SCHWEIZER SERVICE NOTICE

NOTICE NO. N-218

SUBJECT: REPLACEMENT OF AUXILIARY FUEL QUANTITY PLACARD; INSTALLATION OF 269A4106-3 INSTRUMENT CLUSTER AS REPLACEMENT FOR 269A4106 INSTRUMENT CLUSTER.

FIGURE 1. REPLACEMENT OF PLACARD

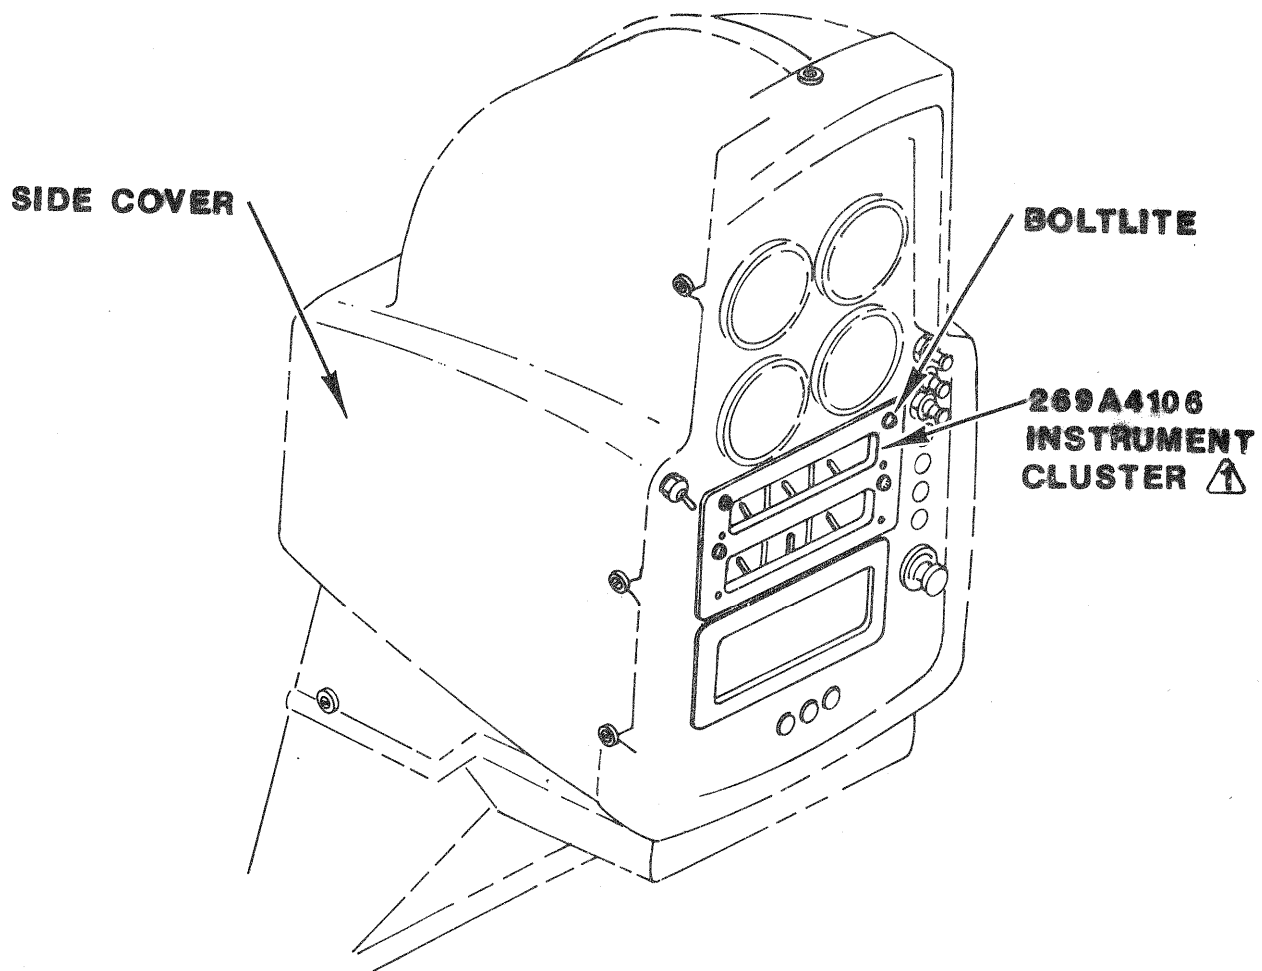
PREFACE: Evaluation of the 269A8385-9 fuel quantity placard (applicable to helicopters having a 30 gal. standard tank and an auxiliary tank) has revealed that some of the data provided by the placard is erroneous. Part I of this Service Information Notice lists a procedure for replacement of the placard with a new 269A8385-11 placard. Part II of this notice lists instructions for installation of 269A4106-3 instrument cluster, incorporating the proper fuel quantity markings, as replacement for 269A4106 instrument

- a. Remove existing 269A8385-9 fuel quantity placard (shown in Figure 1) from instrument panel.
- b. Thoroughly clean area on instrument panel from which placard was removed.
- c. Peel protective backing of 269A8385-11 placard (shown in Figure 1) and install on instrument panel.
- d. Record Compliance with this Service Information Notice in Compliance Record of Helicopter Log Book.

AUX. FUEL QUANTITY							
GAGE	0	5	10	15	20	25	30
TOTAL	0	9	19	31	41	48	49

FUEL QUANTITY							(MAIN & AUX. TANKS)
GAGE	0	5	10	15	20	25	30
TOTAL	0	10	18	27	34	42	49

REMOVE EXISTING 269A8385-9 FUEL QUANTITY PLACARD
AND REPLACE WITH 269A8385-11 PLACARD.
